Patient Safety Alert

AL09-16

Item: Cylinder Valve Explodes from Oxygen Cylinder supplied with Rotarex/Ceodeux Post Type Cylinder Valve

Figure 1

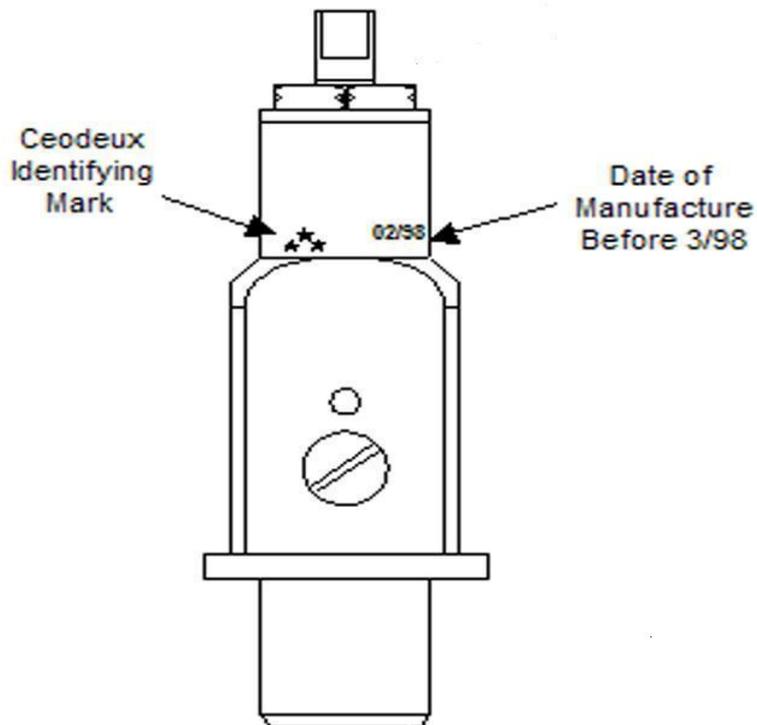
2. The Respiratory Therapy Managers (or their designees) and all other service/department managers (or their designees) that maintain a stock of medical gas cylinders shall inspect all cylinders in their inventories for Rotarex/Ceodeux valves, as shown in Figure 1 on Attachment 2. If any vulnerable valves are found, **do not open or vent these cylinders**, immediately remove them from service, place them in quarantine and label or tag them as "DEFECTIVE." Contact your gas supplier for cylinder return instructions.

The vulnerable valve is limited to **Rotarex/Ceodeux, Inc. post type cylinder valves manufactured prior to March of 1998**, and thus does not apply to newer style valves or other valve manufacturers. Vulnerable valves are those that have the name Ceodeux (or three stars) and are date-stamped prior to **March 1998**. Please refer to Figure 1:

3. All staff that receive medical gas cylinders delivered to their facility shall institute inspections of all cylinders for Rotarex/Ceodeux valves, as described in Attachment 2. If any vulnerable valves are found, **do not open or vent these cylinders**, immediately remove them from service, place them in quarantine and label or tag them as "DEFECTIVE." Contact your gas supplier for cylinder return instructions.
